ADDENDUM #1

A. Project Number: 15-STA-512
B. Project Title: Plaza Upgrade
C. Project Location: 701 W. Riverside Ave, Spokane, WA
D. Owner: Spokane Transit Authority

ADDENDUM # 1

D6

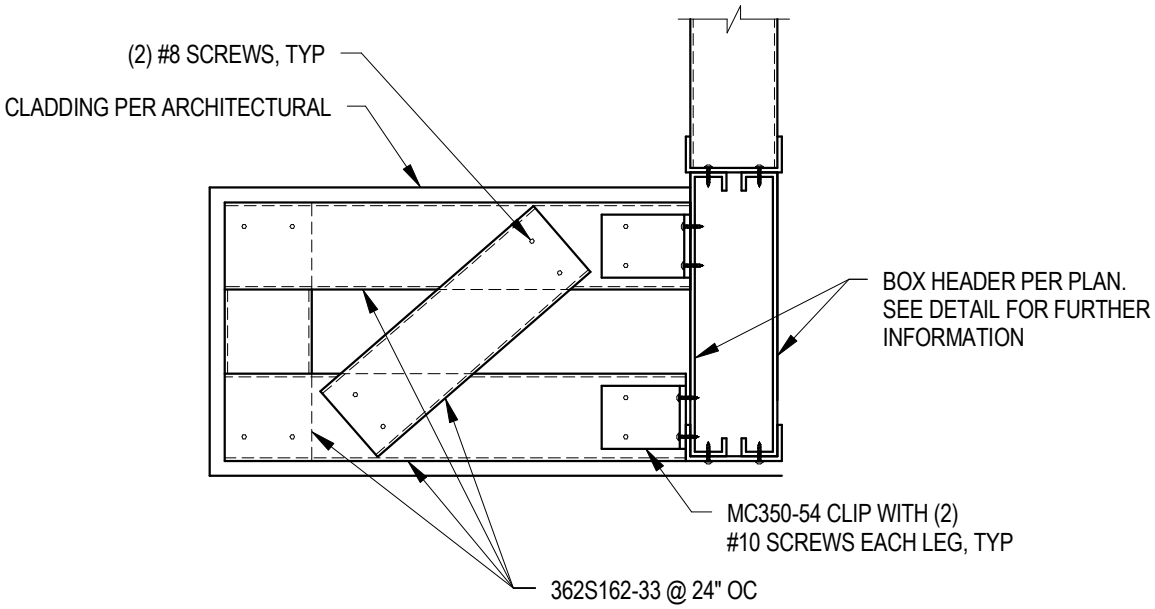
31.	Sheet S-111; Sheet S-501,detail A2 & A3	ADD details for Male & Female Cougar Statues; reference sketches S-02 & S-11
32.	Sheet S-111; Sheet S-121, detail B6; Sheet S-201, detail B6, A3, A5 & A6; Sheet S-501, detail A1, A5 & A6	ADD framing and details for Customer Service Area; reference sketches S-01, S-03, S-06, S-07, S-08, S-09, S-10, & S-12

DESCRIPTION
NEW DETAIL

B6

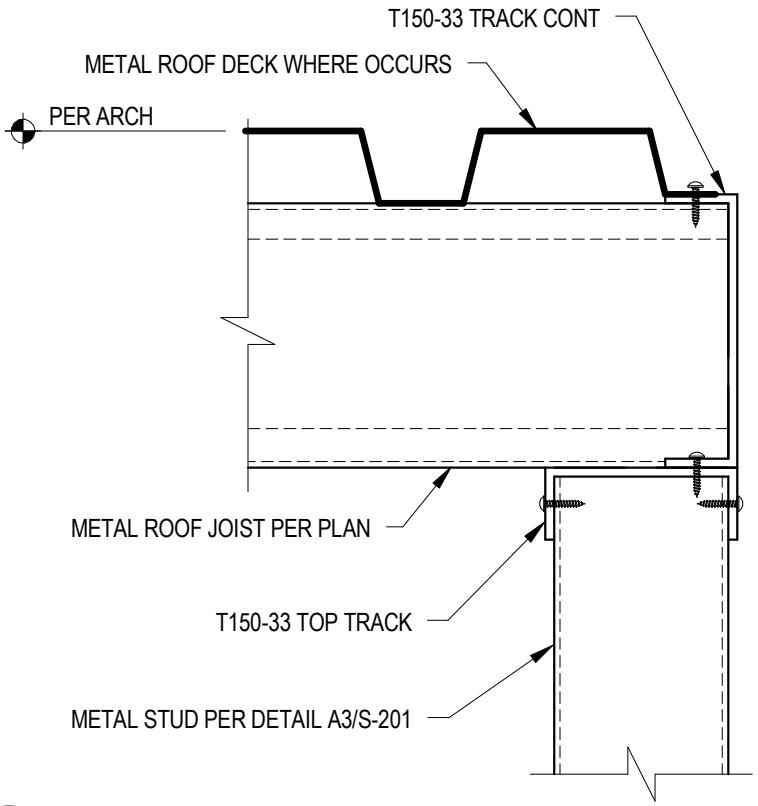
DESCRIPTION
NEW DETAIL

A3 TYPICAL BOX HEADER

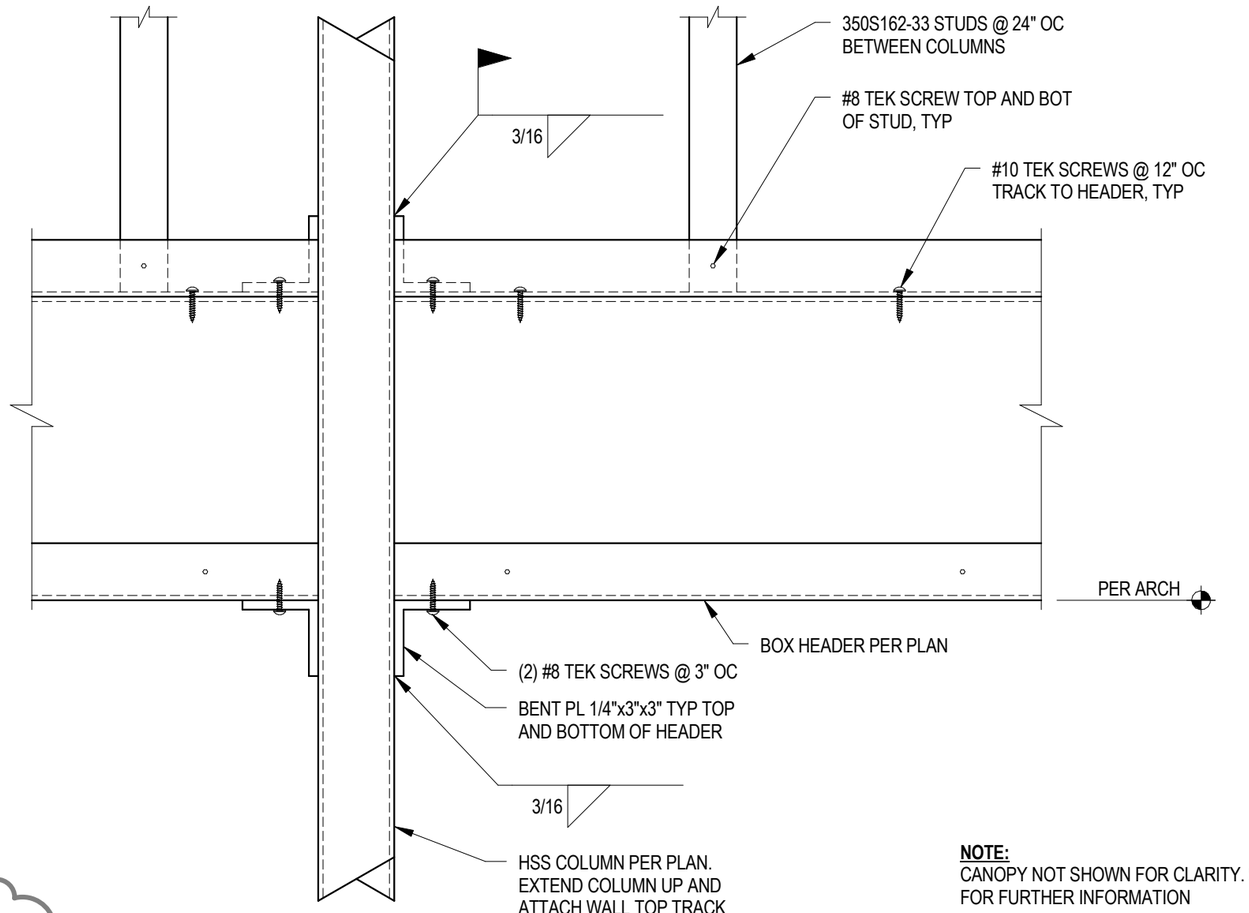
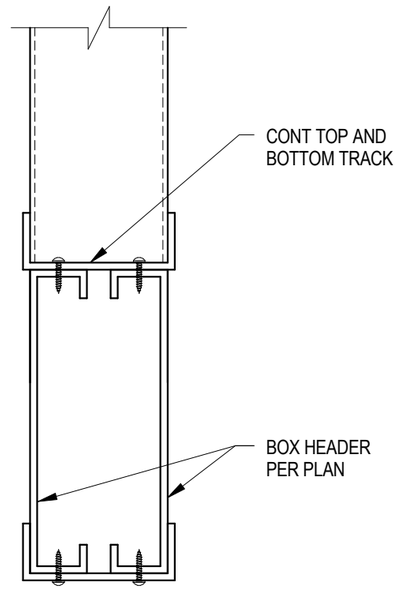
DESCRIPTION
NEW DETAIL

DATE	DRAWN	DWG. NO.	JOB NO.	REF. SHT.
08/13/2015	KVP	S-09	15-STA-512	S-201

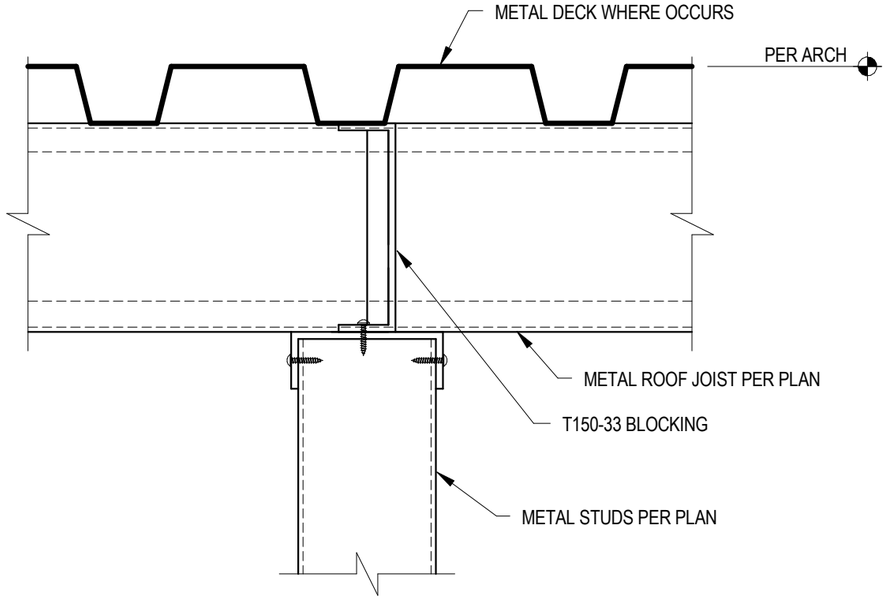
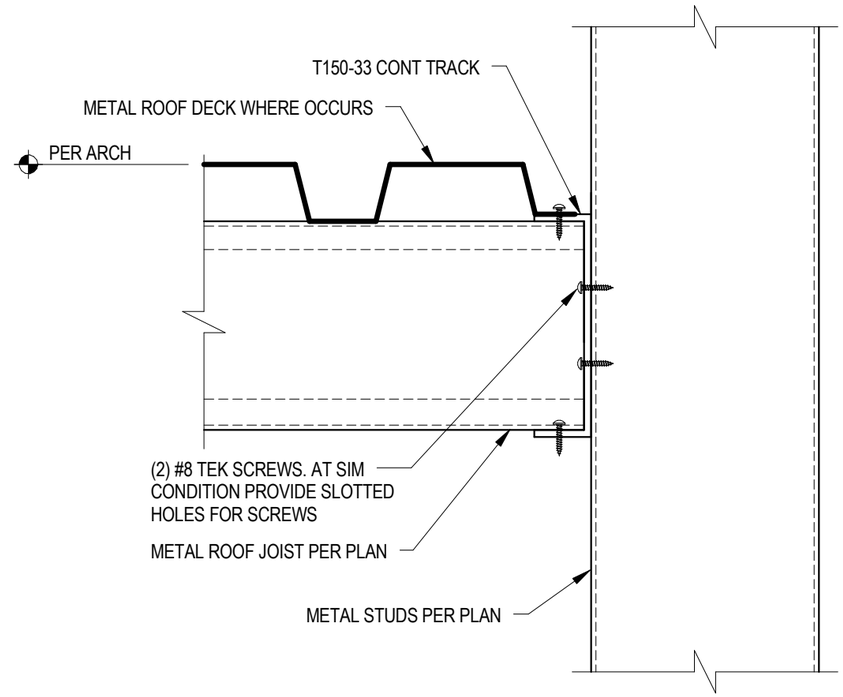
DESCRIPTION
NEW DETAIL

DATE	DRAWN	DWG. NO.	JOB NO.	REF. SHT.
08/13/2015	KVP	S-11	15-STA-512	S-501

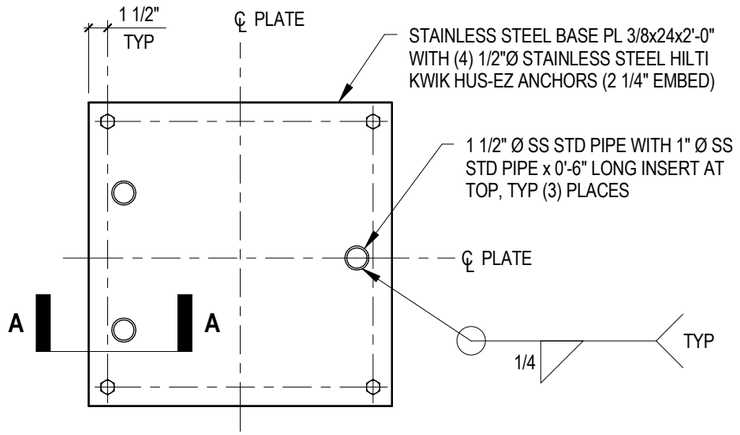
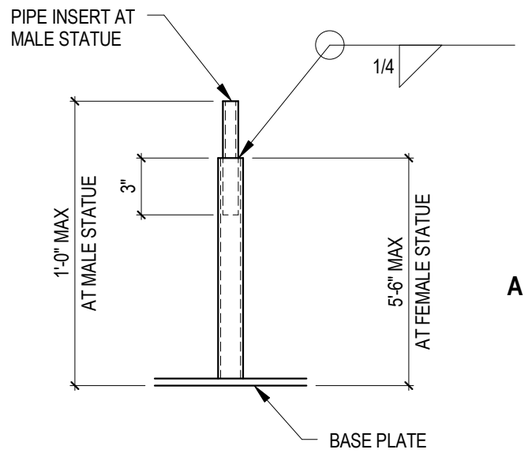
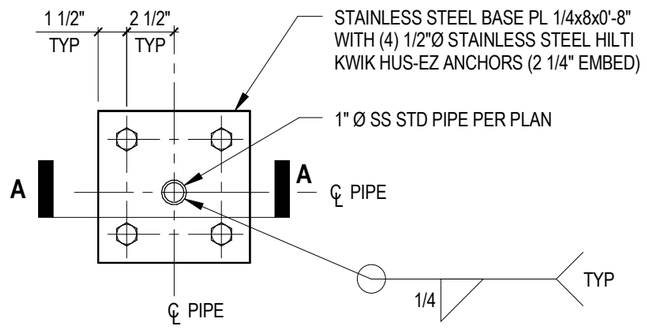
DESCRIPTION
NEW DETAIL

DATE	DRAWN	DWG. NO.	JOB NO.	REF. SHT.
08/13/2015	KVP	S-12	15-STA-512	S-501

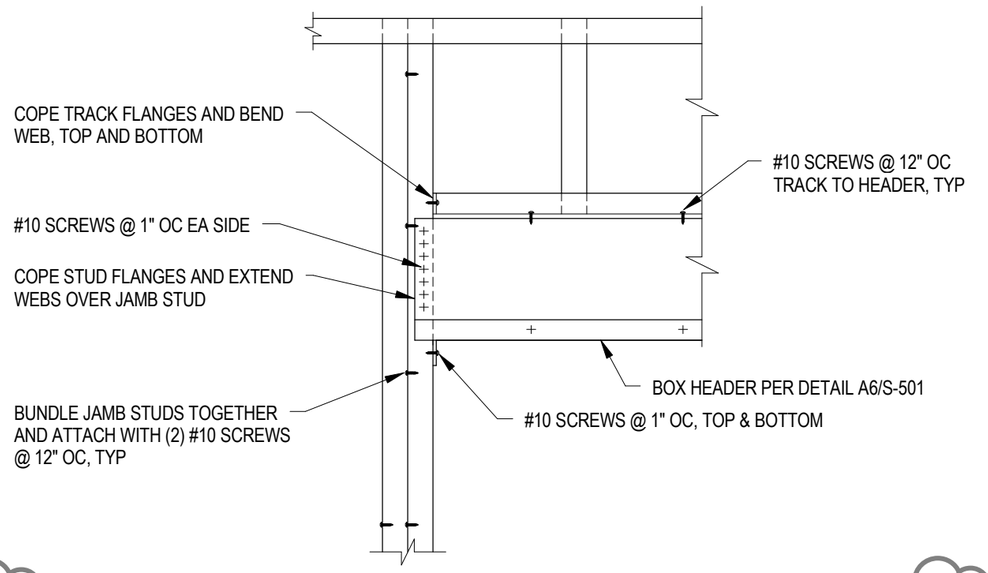
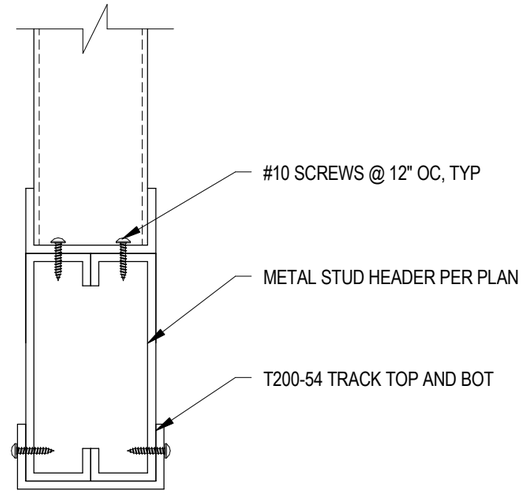
DESCRIPTION
NEW DETAIL

DATE	DRAWN	DWG. NO.	JOB NO.	REF. SHT.
8-12-15	STT	A-02	15-STA-512	A-251

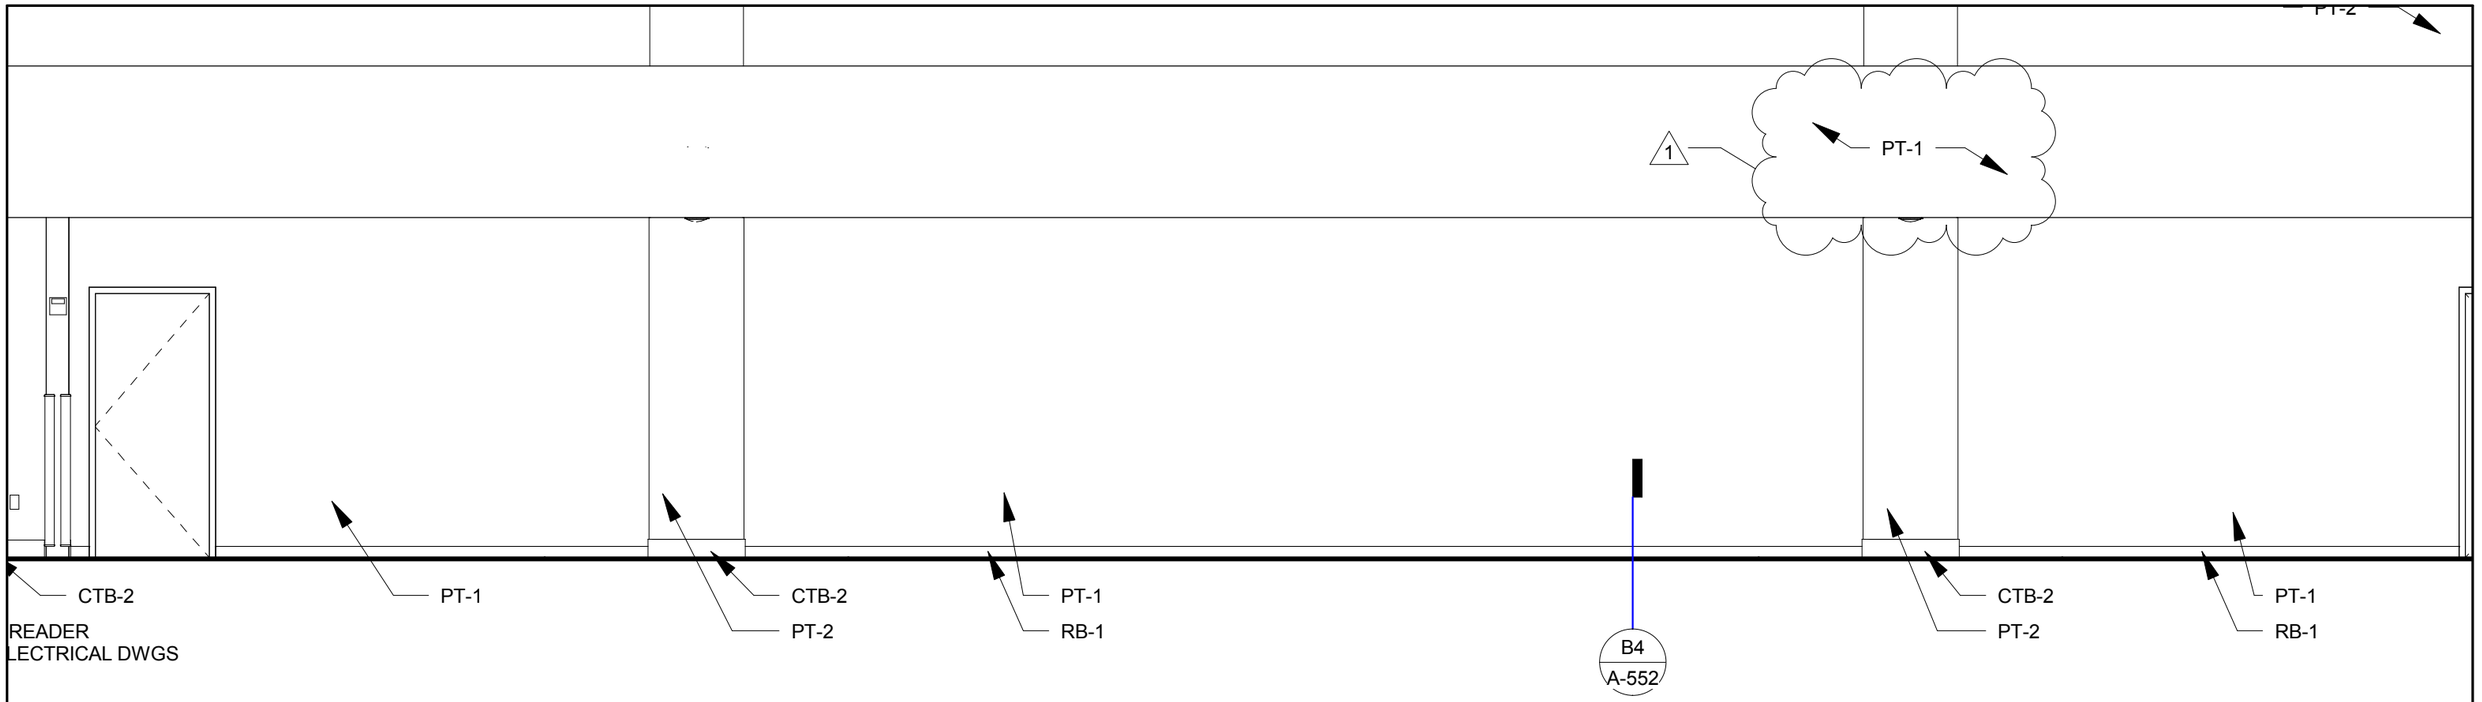
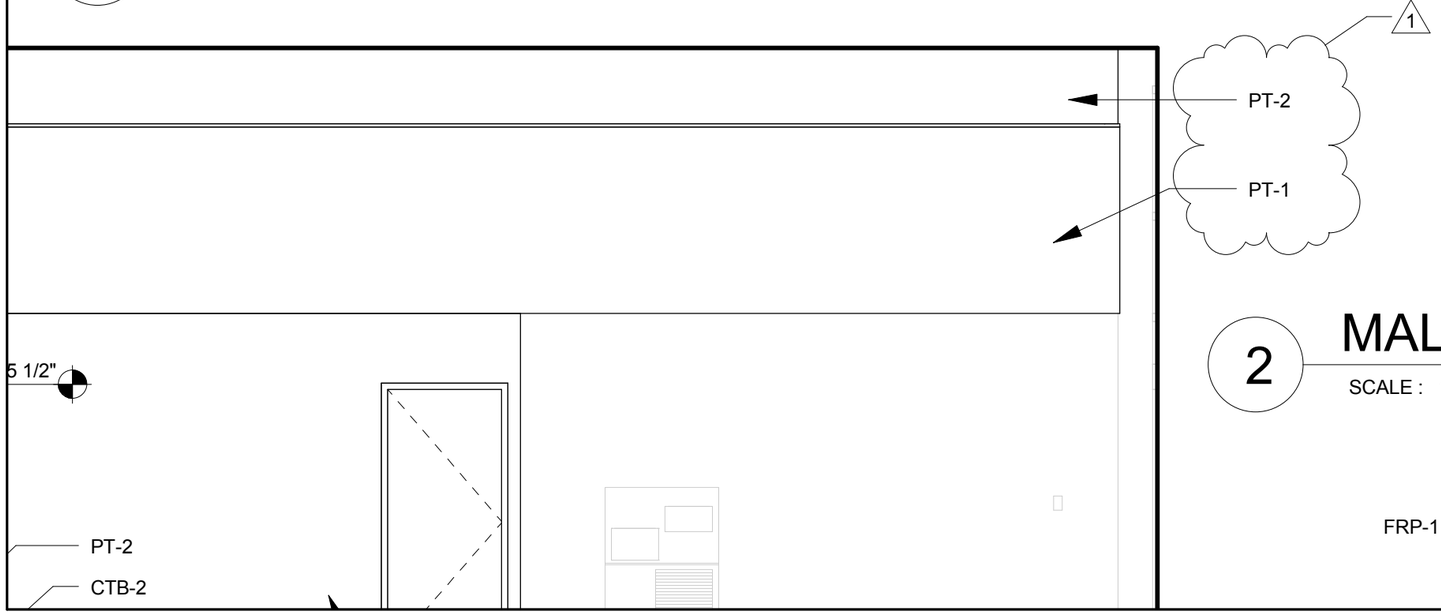
12.	Sheet A-251	See Revision A-02.
13.	Sheet A-252, Detail 6	REVISE signage over Door to read "ZONES 6-10" "SPRAGUE AVENUE".
14.	Sheet A-253	See Revision A-03.

DESCRIPTION
UPDATE PAINT DESIGNATIONS 1/A-251, 2/A-251

DATE	DRAWN	DWG. NO.	JOB NO.	REF. SHT.
8-12-15	STT	A-04	15-STA-512	A-401

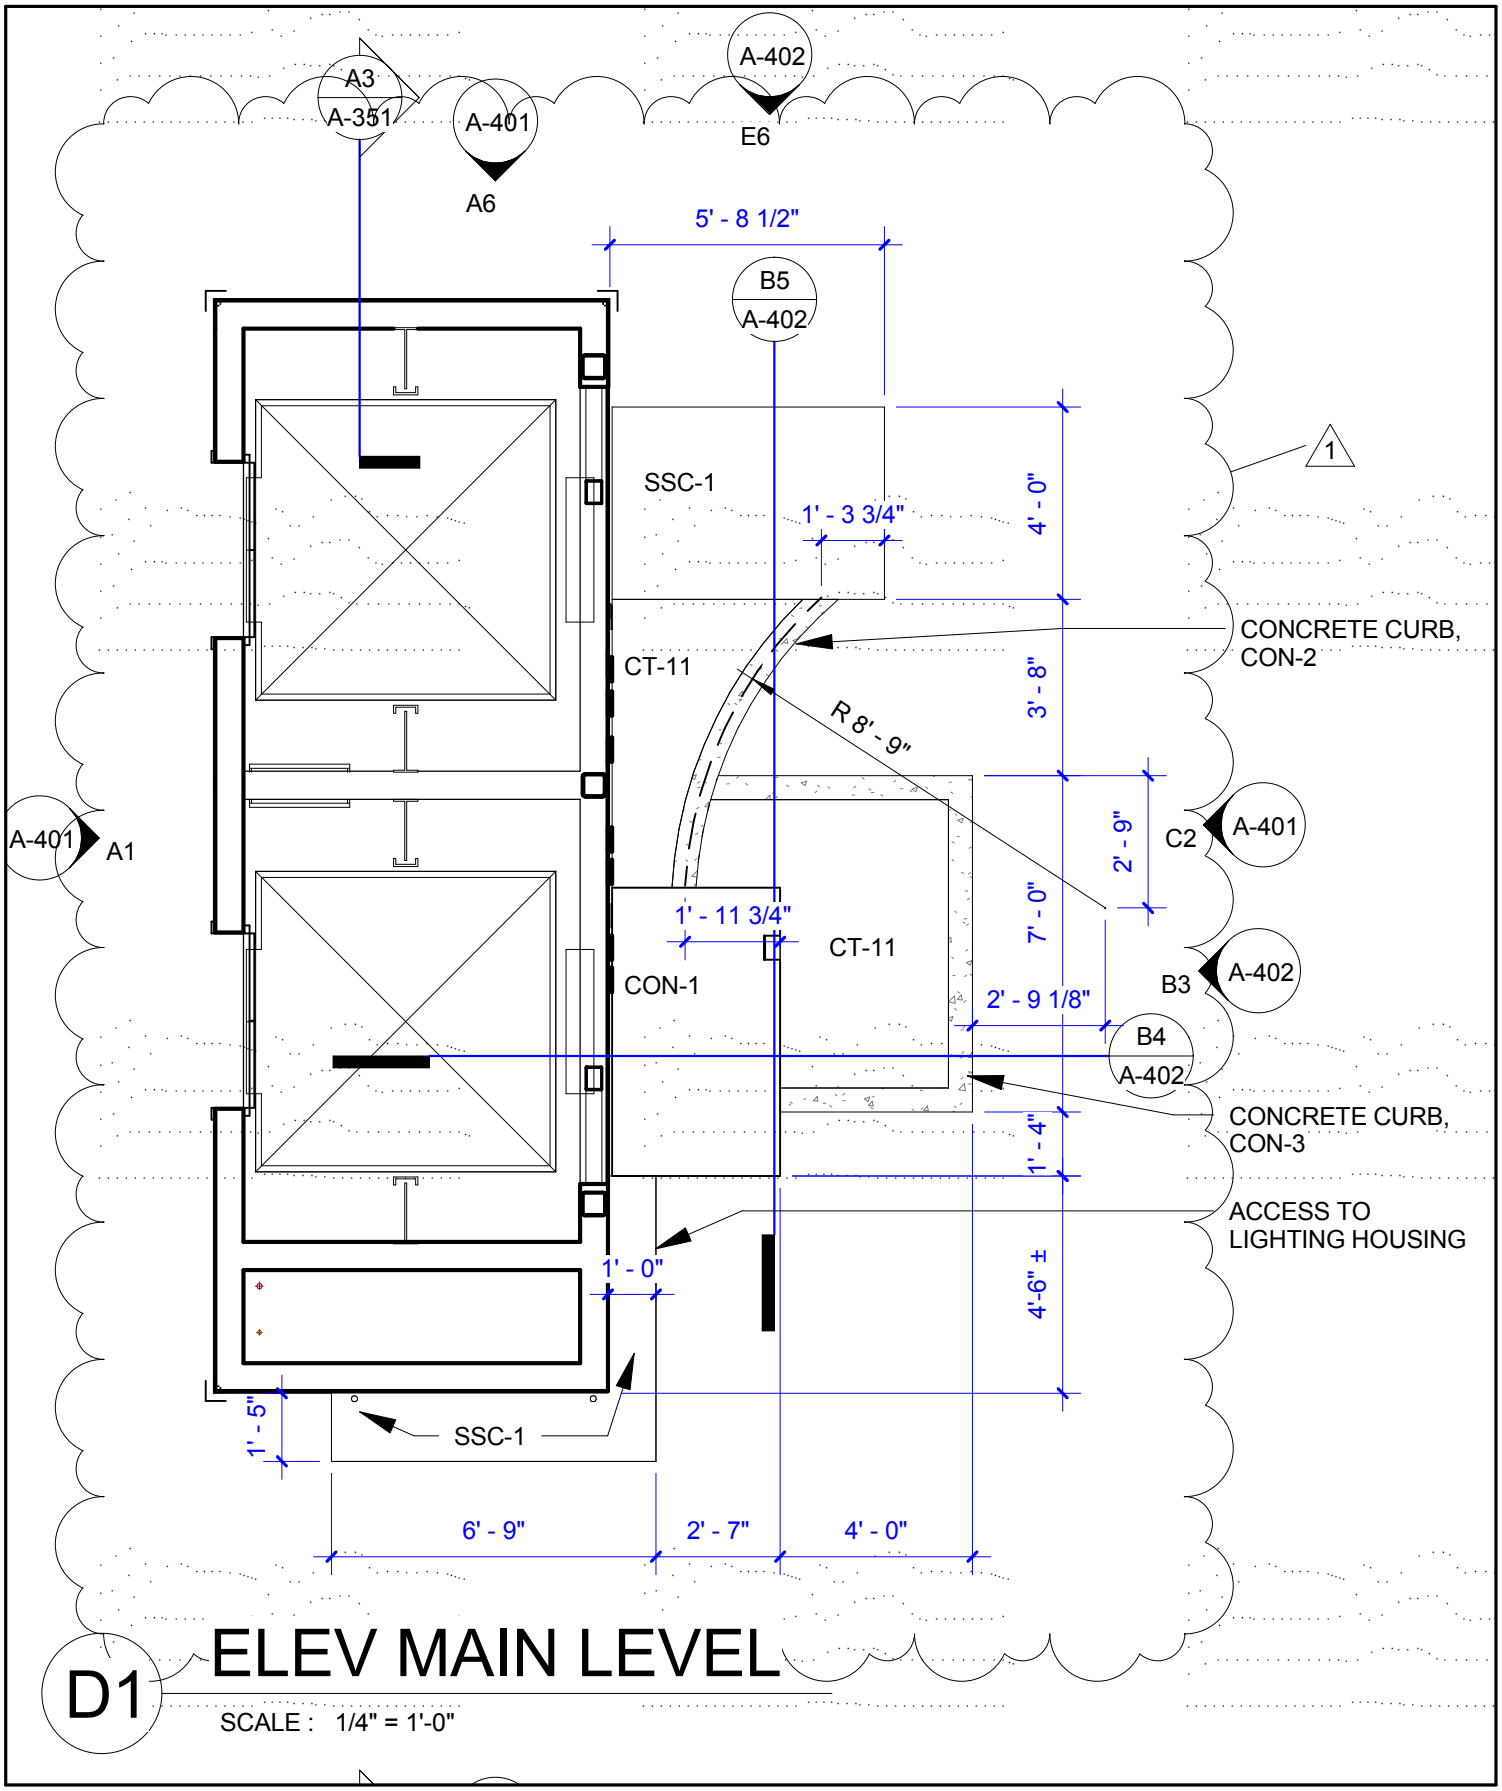
17.	Sheet A-253, Detail 9	ADD dimension to partial height wall reading, "4'-0".
18.	Sheet A-253, Detail 12	ADD dimension to counter reading, "2'-10".
19.	Sheet A-401	See Revision A-04.

DESCRIPTION
ADD STAGE LAYOUT DIMENSIONS AND MATERIAL CALLOUT
